Rev.	Date	By	Ckd	Description
I	17/08/2023	WN	DN	S4.56 Issue 2

30 Fairlight St, Fairlight
30 Fairlight St,
Fairlight, NSW 2094

SCHEDULE OF CHANGES

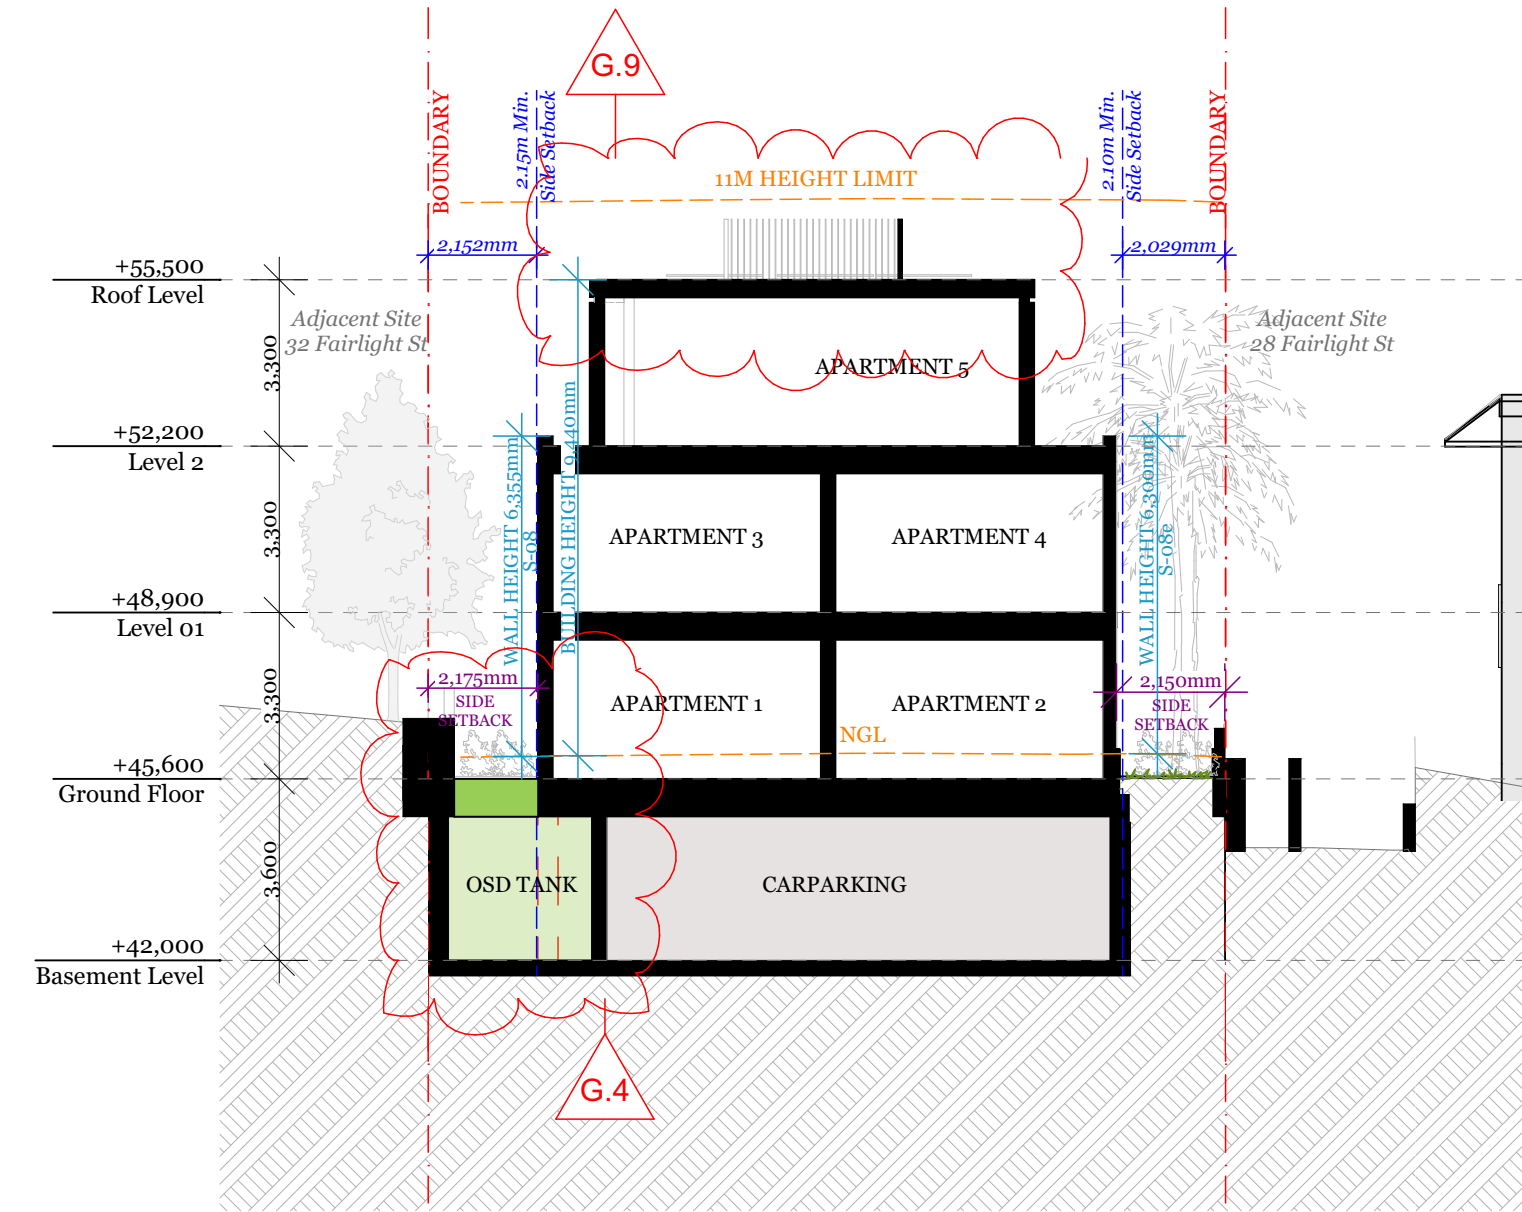
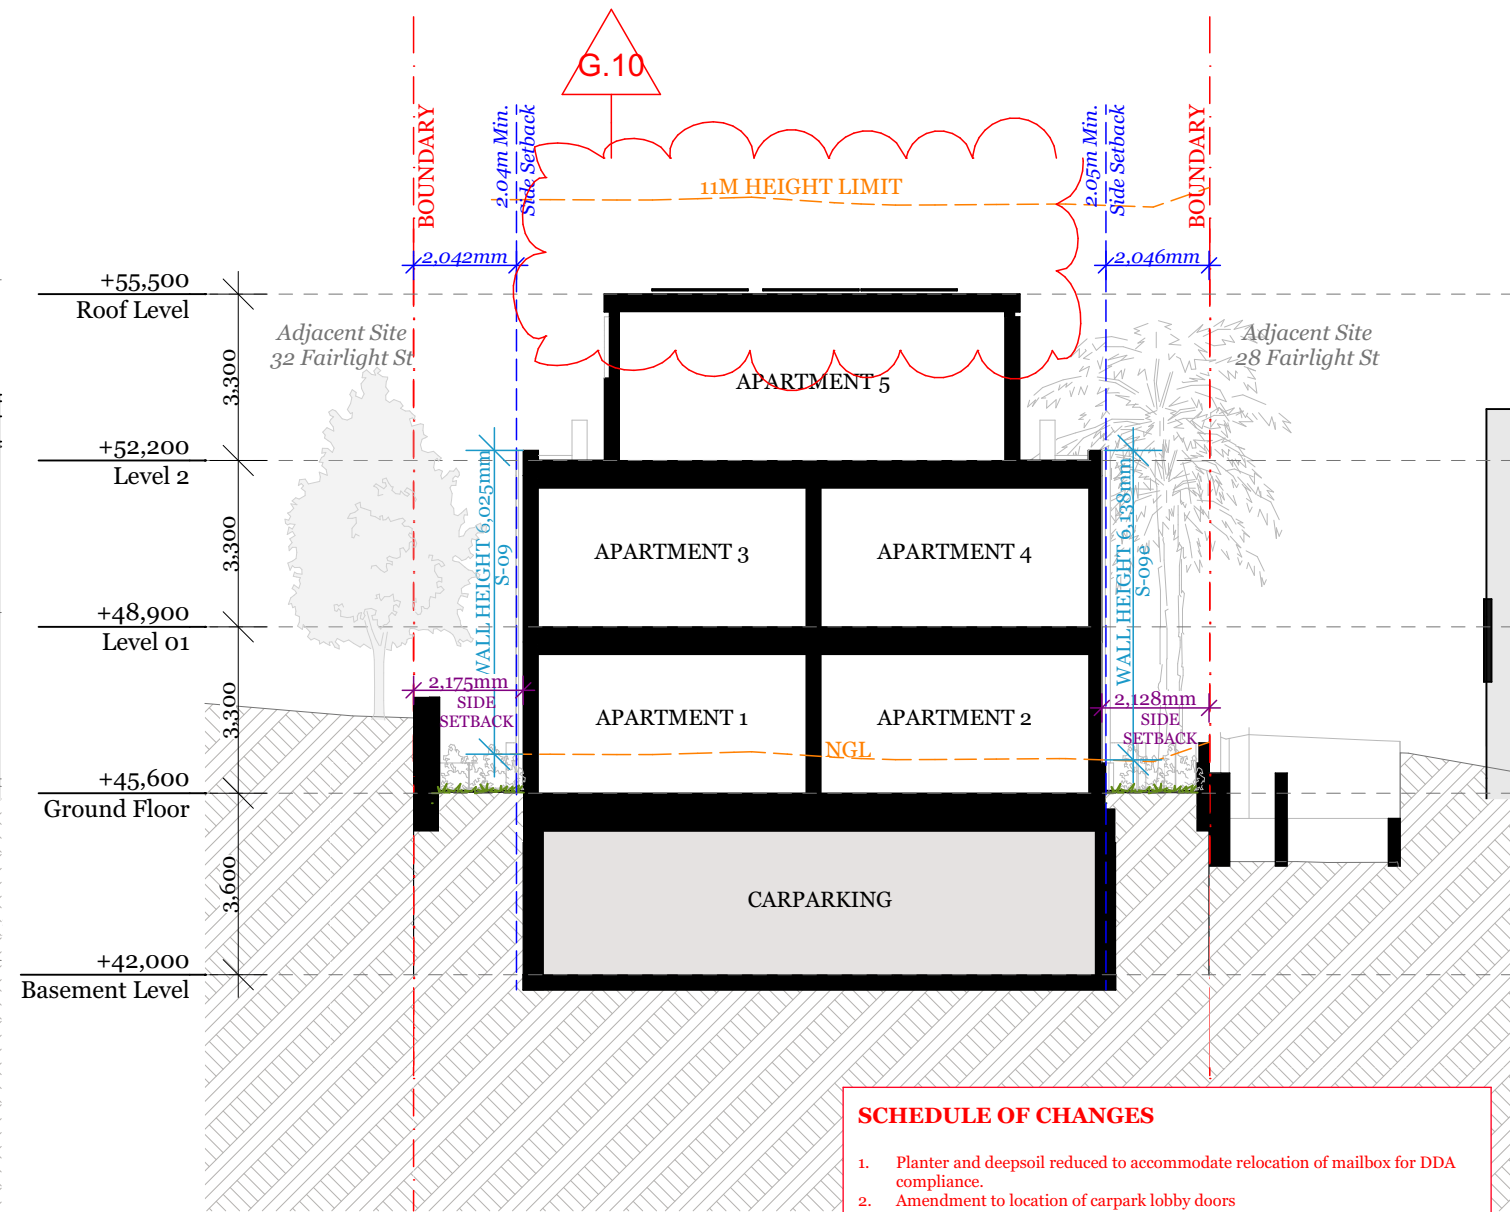
SCHEDULE OF CHANGES	
1.	Planter and deepsoil reduced to accommodate relocation of mailbox for DDA compliance.
2.	Amendment to location of carpark lobby doors
3.	OSD tank extended to accommodate minimum volume as per Stormwater Engineer's report.
4.	Additional door added for compliance as alternate fire egress with NCC D2D6.
5.	Landscaping and planter replaced with terrace hardscape to accommodate OSD tank volume below.
6.	Wall of front terrace rationalised for buildability
7.	Window opening reconfigured.
8.	Internal layout reconfigured and rationalised
9.	Plant services added onto roof including AC condensers, hot water units and mechanical vent exhausts to be concealed with metal screen enclosure
10.	PV panels added.
11.	Skylights deleted.
12.	Solid access hatch cover amended to glazed hatch.
13.	Courtyard landscape amendment.

Drawing Number **DA406**
Revision **A**

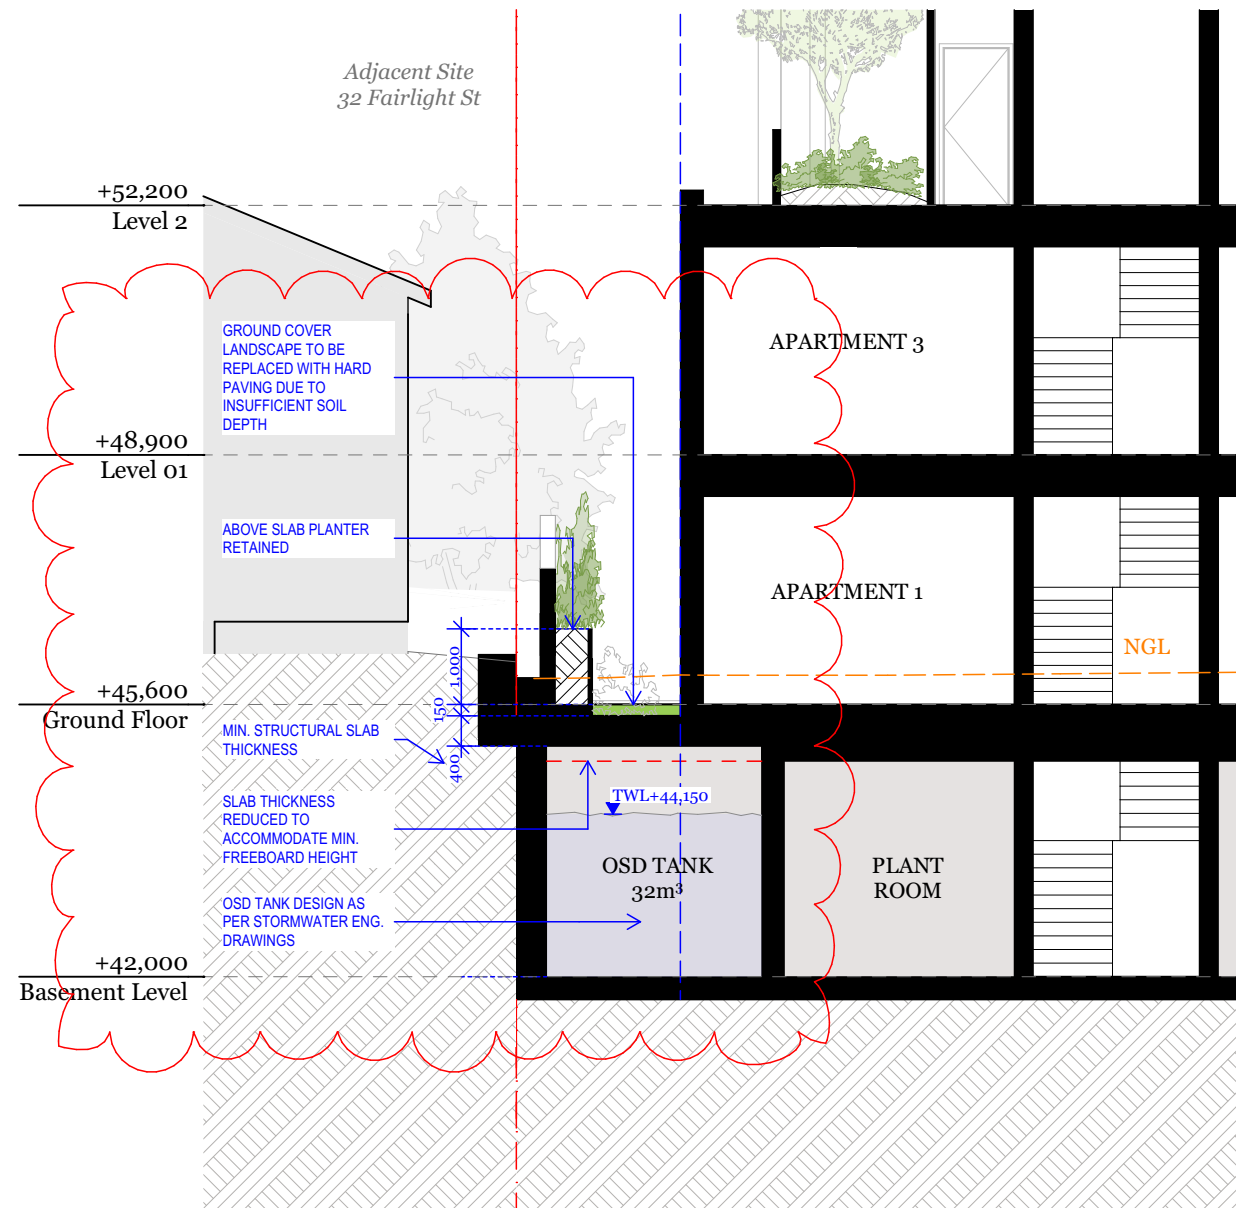
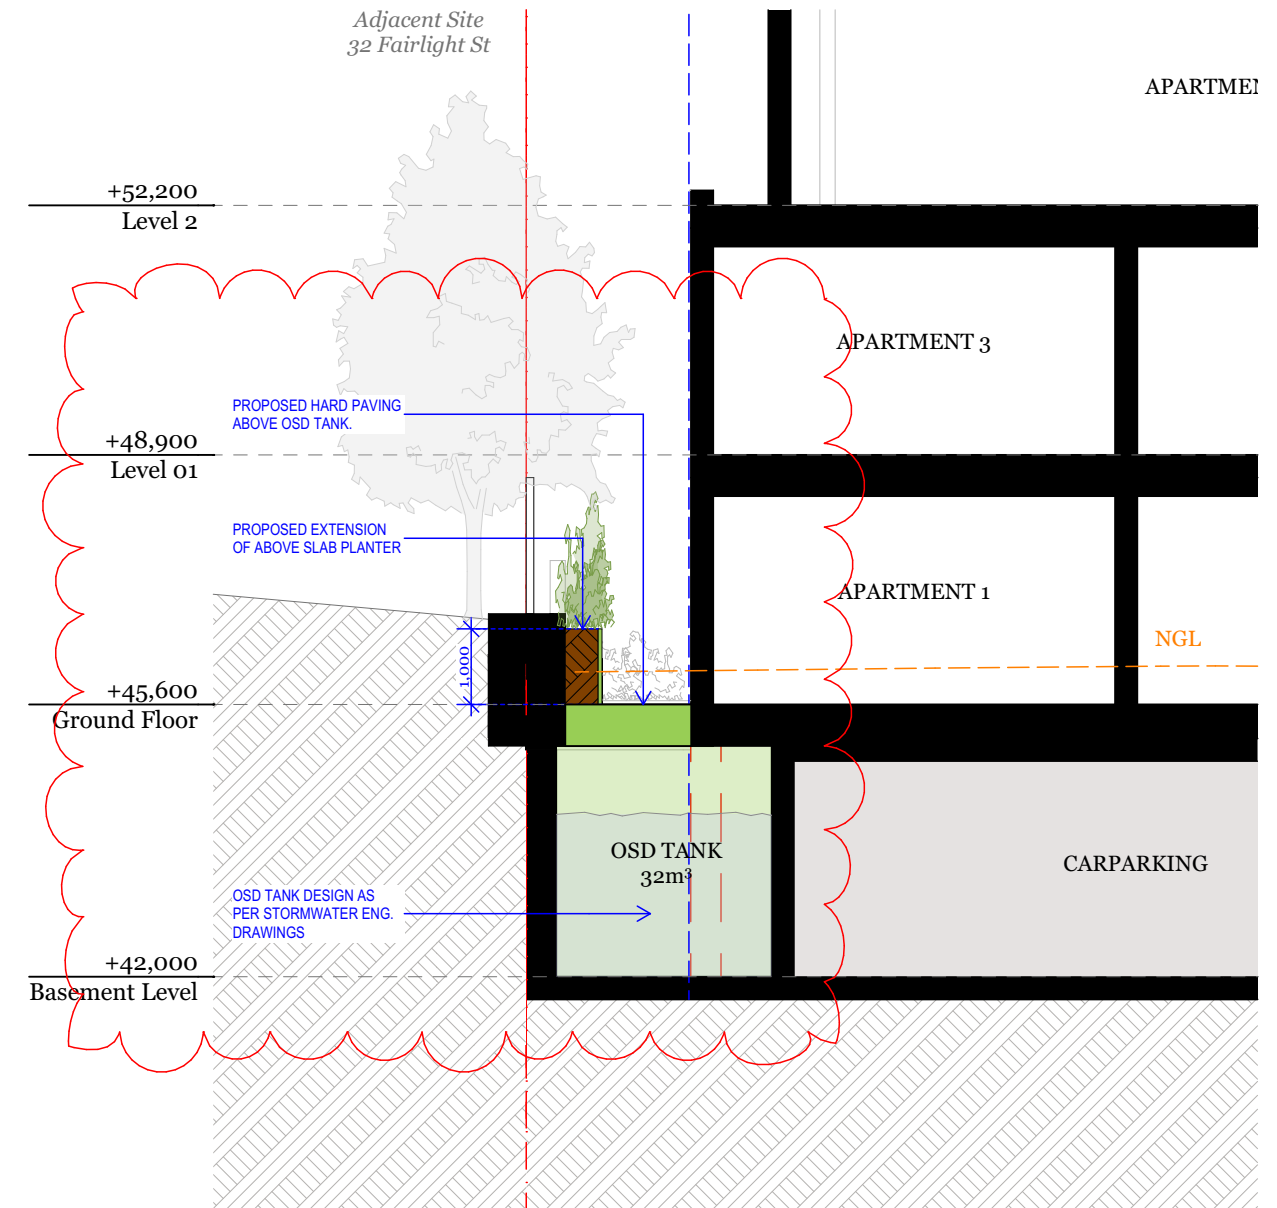
SCHEDULE OF CHANGES	
1.	Planter and deepsoil reduced to accommodate relocation of mailbox for DDA compliance.
2.	Amendment to location of carpark lobby doors
3.	OSD tank extended to accommodate minimum volume as per Stormwater Engineer's report.
4.	Additional door added for compliance as alternate fire egress with NCC D2D6.
5.	Landscaping and planter replaced with terrace hardscape to accommodate OSD tank volume below.
6.	Wall of front terrace rationalised for buildability
7.	Window opening reconfigured.
8.	Internal layout reconfigured and rationalised
9.	Plant services added onto roof including AC condensers, hot water units and mechanical vent exhausts to be concealed with metal screen enclosure
10.	PV panels added.
11.	Skylights deleted.
12.	Solid access hatch cover amended to glazed hatch.
13.	Courtyard landscape amendment.

Project Name	30 Fairlight St, Fairlight	Project Number	00012781
Project Address	30 Fairlight St, Fairlight, NSW 2094	Drawing Name	Deep Soil Calc. (A3)
		Scale	August 2023
		Date	
Client	Adjani Pty Ltd	Drawing Number	DA505
		Revision	G

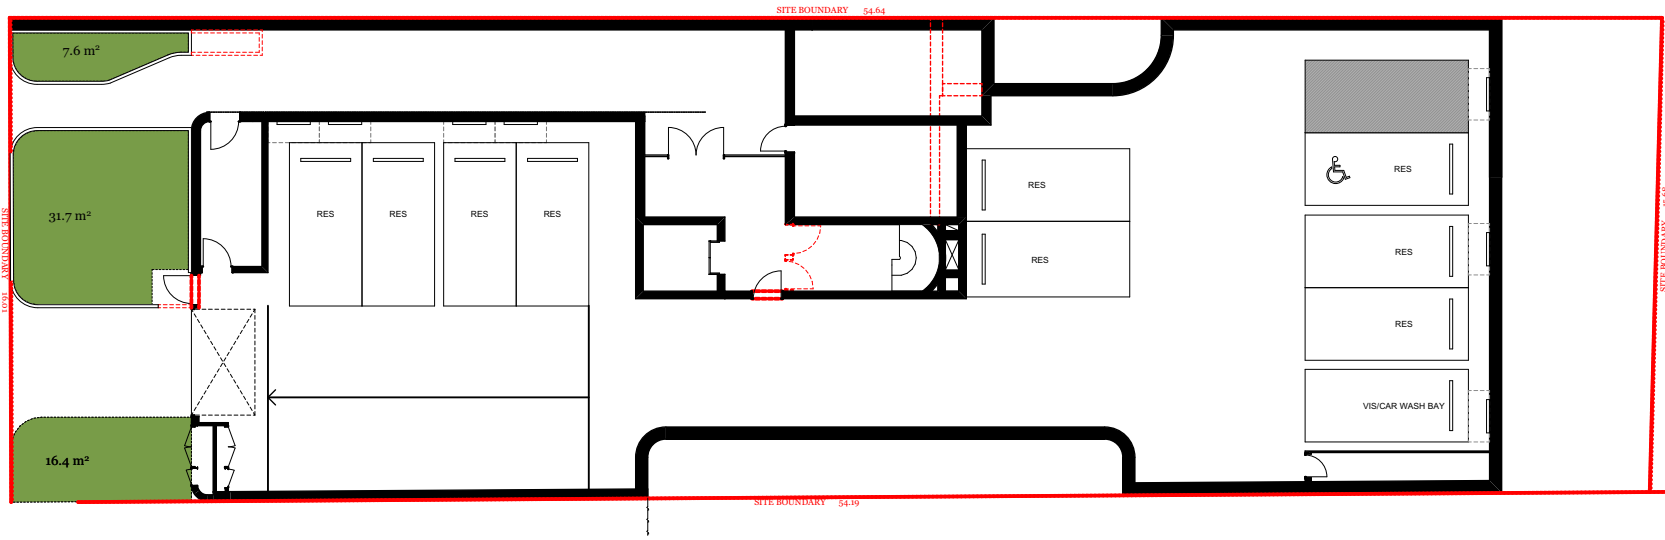
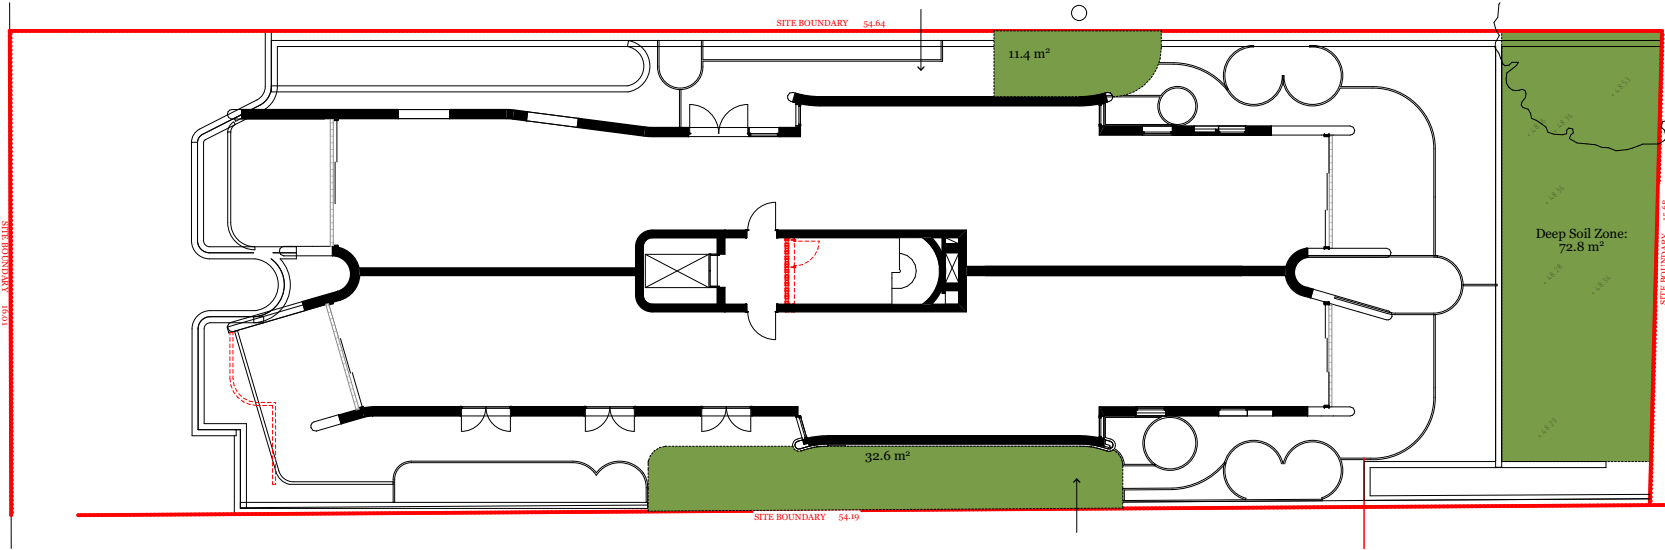
Basement Level
Proposed Deep Soil: 58.5sqm

Ground Floor
Proposed Deep Soil: 119.6sqm

Site Area	862sqm	
Area Required As Deep Soil	60.3sqm	7%
Area Approved As Deep Soil	178.1sqm	20.7%
Area Proposed As Deep Soil	172.5sqm	20.0%
